Road & Bridge Design Publications

Monthly Update – March 2014

Special Details

**SAFETY EDGE FOR HMA PAVEMENT
OVERLAY**

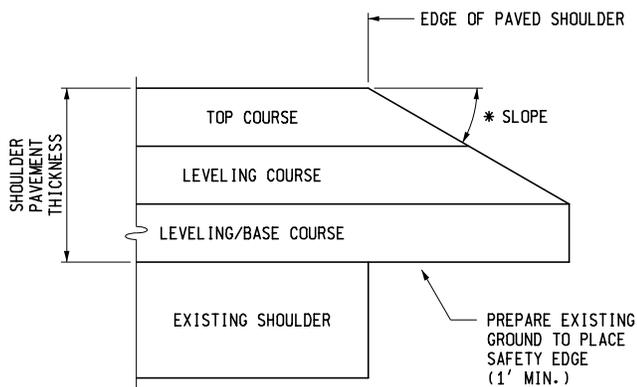
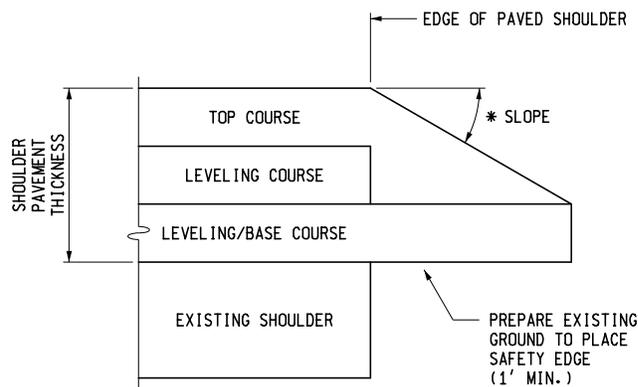
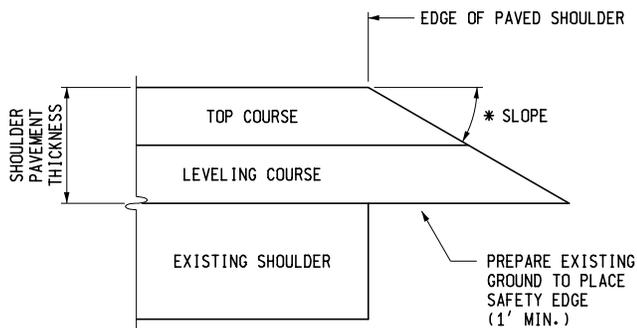
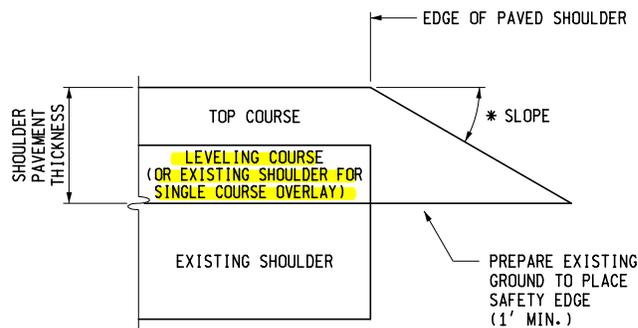
R-110-A: Safety Edge: In the sketches for pavement thicknesses 5” or less (configuration 2), revised the “leveling course” layer to “leveling course (or existing shoulder for single course overlays)”.

**CONFIGURATION 2 FOR
PAVEMENT THICKNESS 5" OR LESS**

BRIDGE CROSS SECTIONS
 TRUNKLINE, COUNTY & CITY BRIDGES

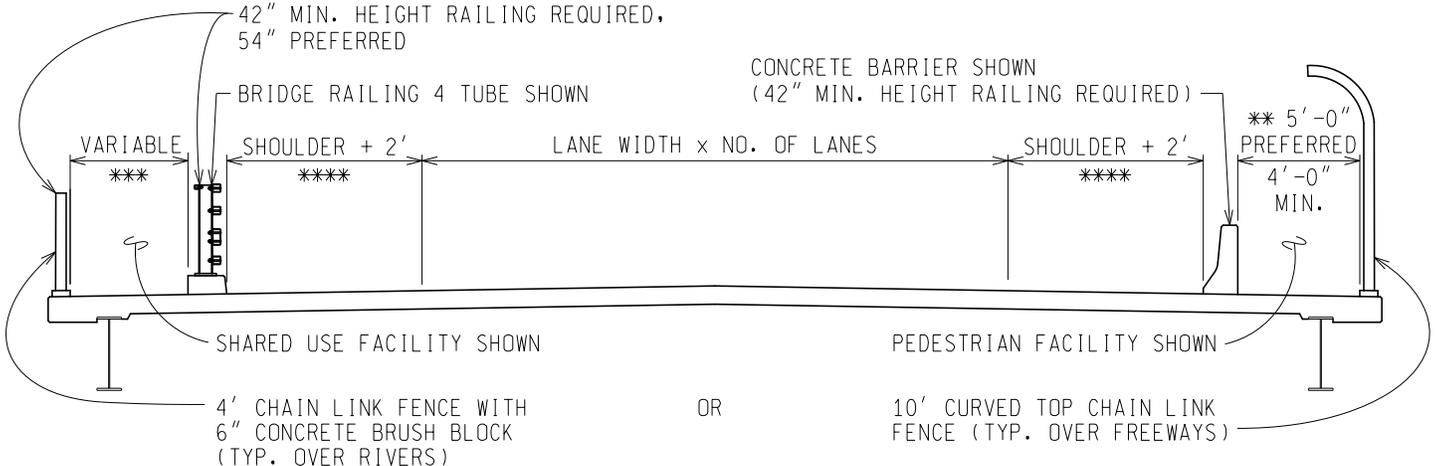
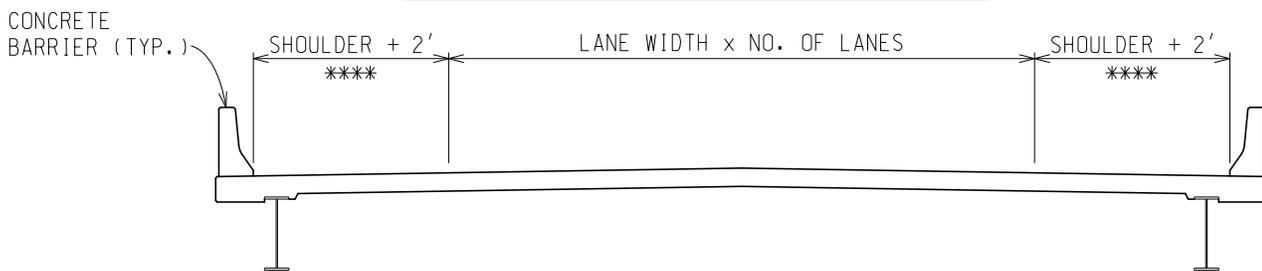
6.05.02: Updated note for shoulder widths with reference to Bridge Design Manual Chapter 7 and AASHTO, “A Policy on Geometric Design of Highways and Streets”.

FOR MINIMUM APPROACH SHOULDER WIDTHS SEE BRIDGE DESIGN MANUAL CHAPTER 7 AND AASHTO "A POLICY ON GEOMETRIC DESIGN OF HIGHWAYS AND STREETS".
